Service Action: Replace Both Sun Visors

R55 (Clubman)

R56 (Cooper)

R60 (Countryman)

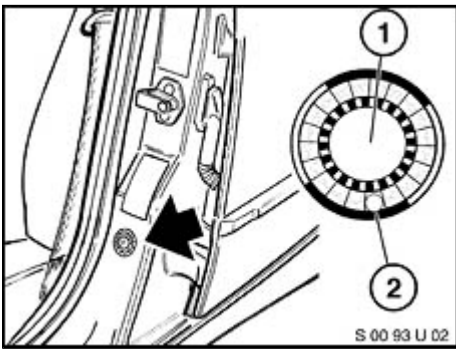
This Service Action has been assigned code number **57**. After the vehicle has been checked and/or corrected, obtain a label (MD20-040) and:

- A. Emboss your MINI dealer warranty number in the middle of the label (1);
- B. Punch out code number **57** (2), printed on the

- C. Affix the label to the B-pillar as shown.

NEW If the vehicle already has a label from a previous Service Action, affix the new label next to the old one. Do not affix one label on top of another one because a number from an underlying label could appear in the punched-out hole of the new label.
